# UNITED STATES PATENT AND TRADEMARK OFFICE

APPLICATION NO.	FILING DATE	FIRST NAMED INVENTOR	ATTORNEY DOCKET NO.	CONFIRMATION NO.
10/573,871	12/27/2006	Nigel Cronin	0934.0048	7093
70653 7590 01/13/2011 LAW OFFICES OF EUGENE M. CUMMINGS, P.C. ONE NORTH WACKER DRIVE SUITE 4130 CHICAGO, IL 60606			EXAMINER DELLA, JAYMI E	
			ART UNIT 3739	PAPER NUMBER
			MAIL DATE 01/13/2011	DELIVERY MODE PAPER

<b>Office Action Summary</b>	<b>Application No.</b> 10/573,871	<b>Applicant(s)</b> CRONIN ET AL.	
	<b>Examiner</b> JAYMI DELLA	<b>Art Unit</b> 3739

### **DETAILED ACTION**

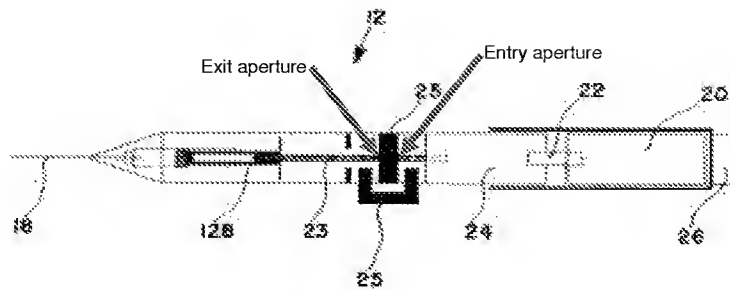
35. Concerning **claims 61-63**, Junior further discloses that the housing (25) includes at least one aperture that includes an entry aperture, through which the cable enters the housing and an exit aperture, through which the cable exits the housing, that permits **substantially** linear motion of the cable relative to the housing as illustrated in annotated Fig. 2 below.
